| Model | ST26 (Matt20B) | Volt/Hz | Date of Modification | Serial Number |
| Modified Article | Cushion 39 x 11 | | | |
| Reason for Modification | To eliminate vibration noise from the bin drive bracket, two rubber cushions have been added between the frame and the bracket as shown in the illustration below. | | | |

| Modified Article | Bracket - Lower Exit Sensor | | | |

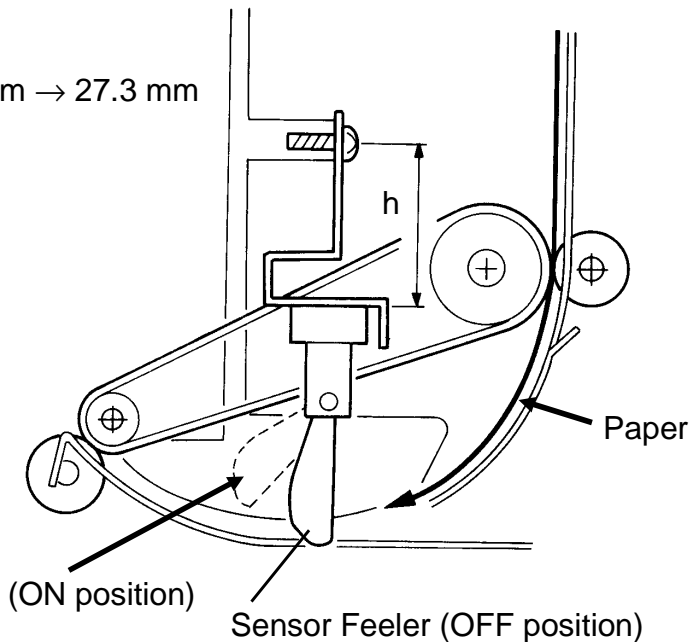
| Reason for Modification | To ensure that the paper exit sensor functions correctly | | | |

The paper exit sensor feeler sometimes malfunctions and turns off, even though a sheet of paper is still underneath the sensor. To lower the sensor feeler position and ensure that the sensor is actuated correctly, the height of the sensor bracket has been changed as shown in the illustration.

| Old P/N | New P/N | Description | Q'ty Used | Inter-change-ability | Parts Catalog | |
|----------|----------|-----------------------------|-----------|----------------------|---------------|------|
| A3742183 | A5542183 | Bracket - Lower Exit Sensor | 1 → 1 | X/O | 8 | 9 |

h : 24.5 mm → 27.3 mm

| New P/N | Description | Parts Catalog | |
|-----------|--------------------|---------------|------|
| A554 1151 | S/S Mounting Frame | 26 | 7 |

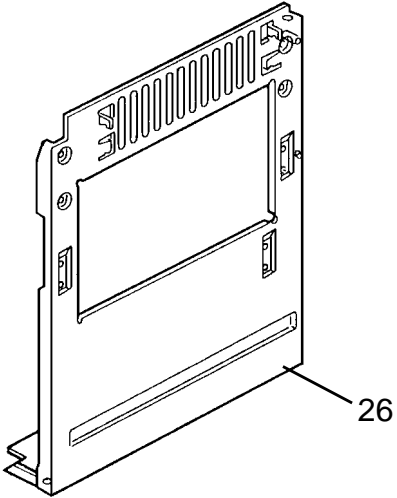
| Reason for Modification | Part Number assigned for the sorter mounting frame. | | | |

| Modified Article | Cushion | No serial number cut-in information. | | |

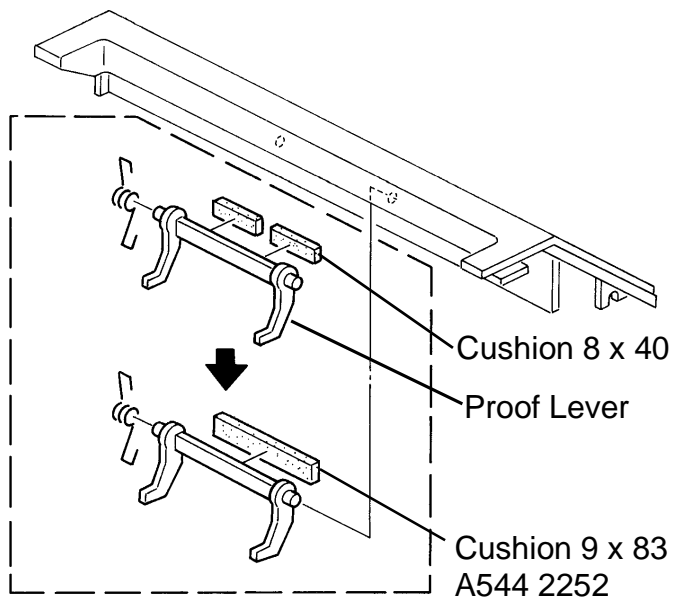
| Reason for Modification | To facilitate assembly in the factory | | | |

| Old P/N | New P/N | Description | Q'ty Used | Inter-changeability | Parts Catalog | |
|-----------|-----------|----------------|-----------|---------------------|---------------|------|
| A498 2266 | | Cushion 8 x 40 | 2 → 0 | O/O | 16 | 3 |
| | A554 2252 | Cushion 9 x 83 | 0 → 1 | | 16 | 3 |

Bin Shaft Cover - Front

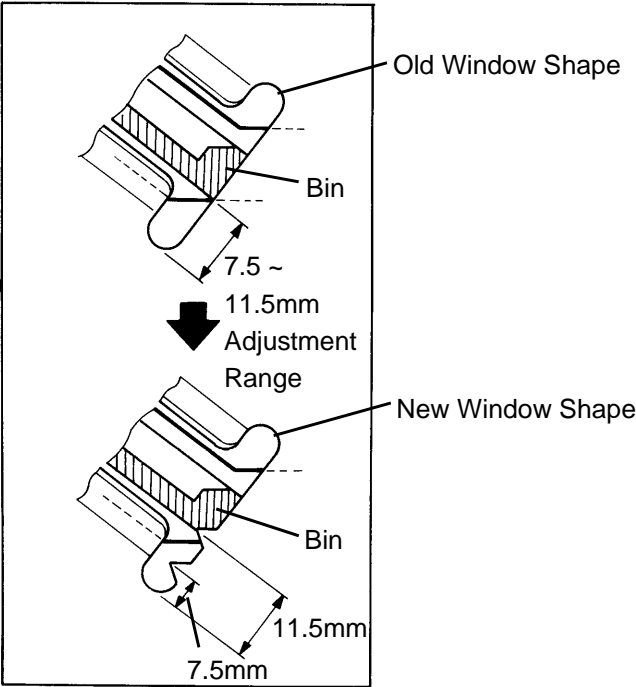
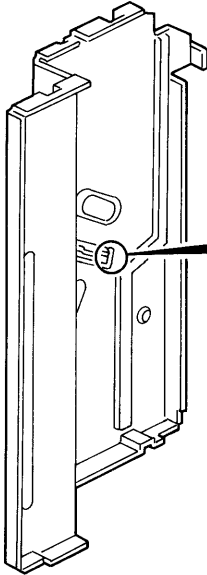
| Reason for Modification | To facilitate the bin home sensor adjustment | | | |

The window shape of the Front Bin Shaft Cover has been changed as shown in the illustration for the above reason.

| Old P/N | New P/N | Description | Q'ty Used | Inter-changeability | Parts Catalog | |
|-----------|-----------|-------------------------|-----------|---------------------|---------------|------|
| A374 1622 | A554 1622 | Bin Shaft Cover - Front | 1 → 1 | O/O | 28 | 11 |

| Modified Article | Exit Guide Spacer and Vibrating Roller Holder | | | |

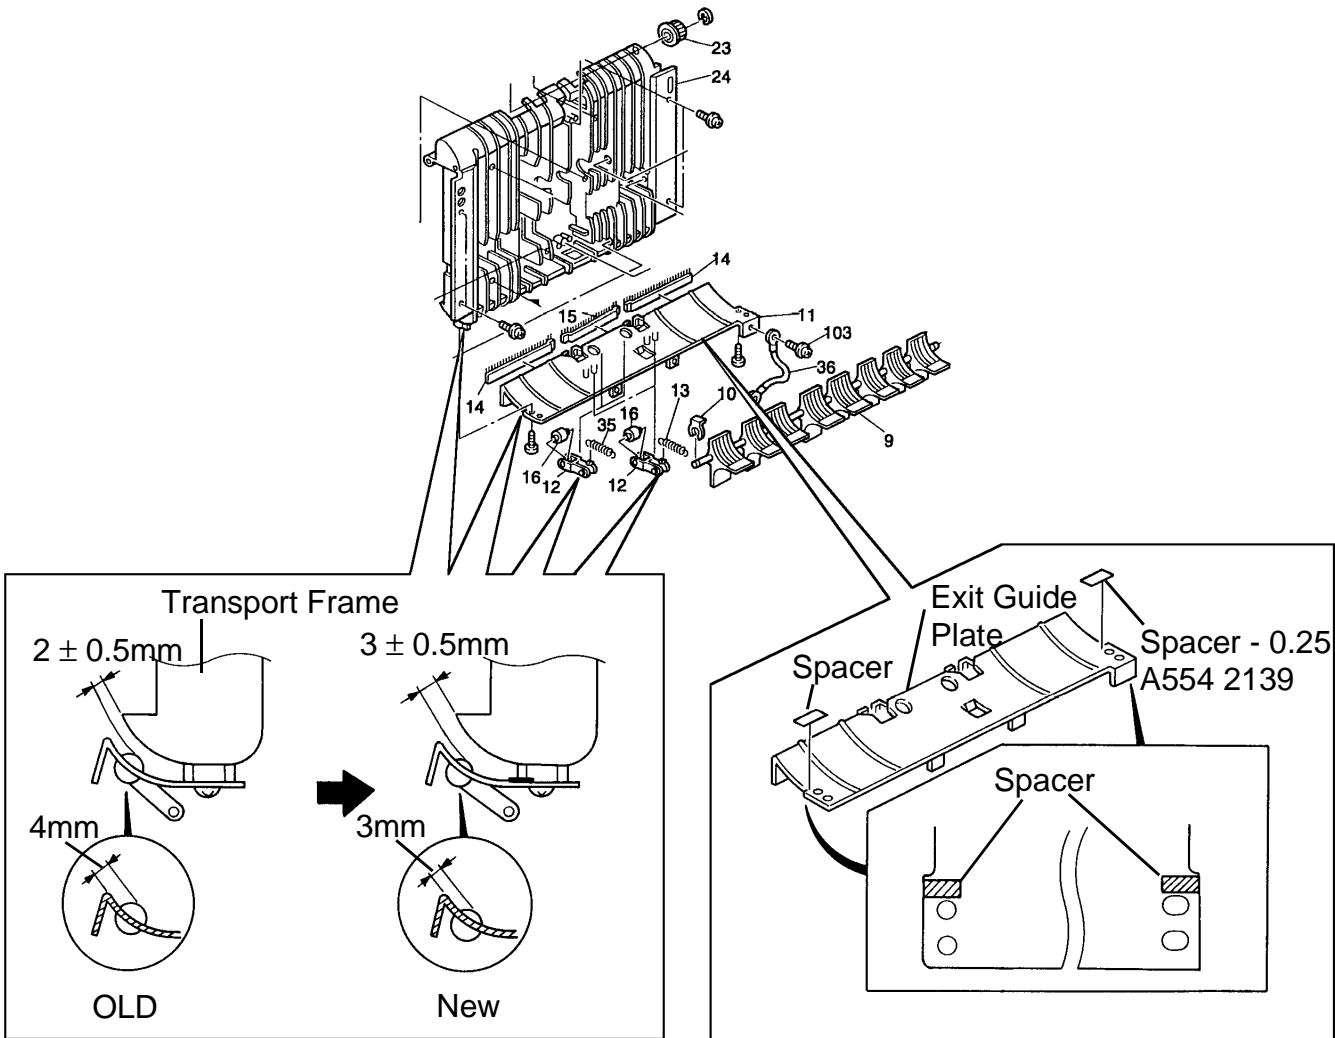
| Reason for Modification | To prevent paper skew | | | |

To prevent paper from skewing, two spacers have been added on the exit guide plate, and the vibrating roller holders have been changed as shown in the illustration.

| Old P/N | New P/N | Description | Q'ty Used | Inter-change-ability | Parts Catalog | |
|-----------|-----------|------------------|-----------|----------------------|---------------|------|
| | A554 2139 | Spacer - 0.25 | 0 → 2 | | 41 | 9 |
| A554 2171 | A554 2173 | Vibrating Holder | 2 → 2 | X/O | 12 | 9 |

| Modified Article | End Fence Stopper | | | |

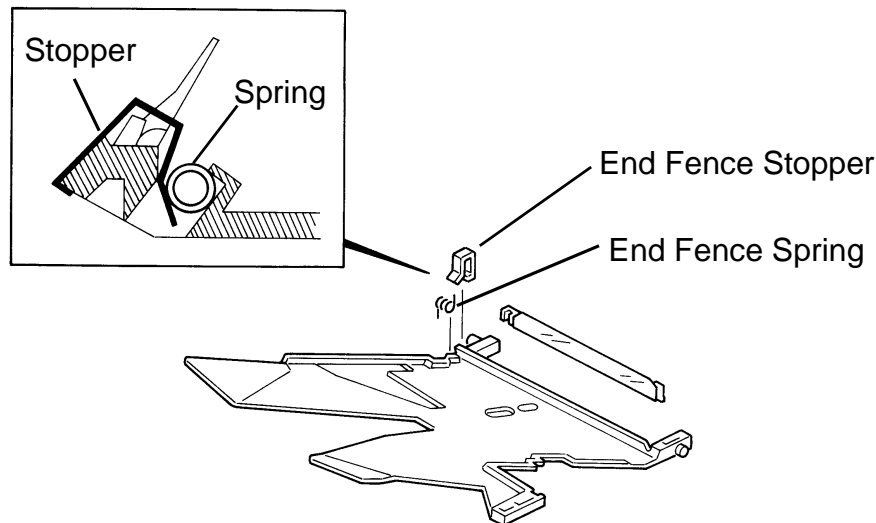
| Reason for Modification | To prevent the end fence springs of the sorter bins from coming off | | | |

The end fence stoppers have been added to each bin for the above reason. The parts numbers for the Bin Ass'y have also been changed as follows.

| Old P/N | New P/N | Description | Q'ty Used | Inter-change-ability | Parts Catalog | |
|-----------|-----------|-------------------|-----------|----------------------|---------------|------|
| | A554 3512 | End Fence Stopper | 0 → 20 | | 24 | 15 |
| A554 3505 | A554 3506 | Bin Ass'y | 19 → 19 | X/O | 15 | 15 |
| A554 3507 | A554 3508 | Lower Bin Ass'y | 1 → 1 | X/O | 22 | 15 |

| Correct P/N | Description | Q'ty Used | Parts Catalog | |
|-------------|----------------------|-----------|---------------|------|
| A554 1910 | Cushion - Rear Cover | 0 → 1 | 22 | 3 |

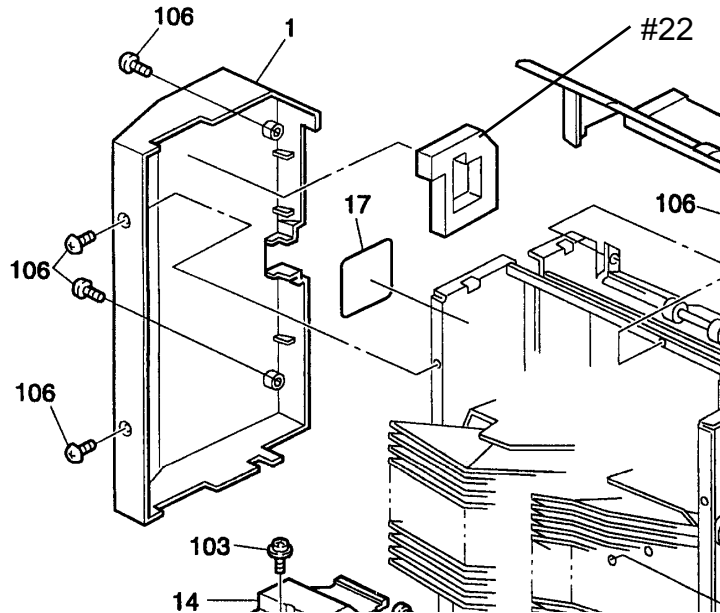
A part number for the cushion on the rear cover has been assigned.
Please add this part number to your parts catalog.
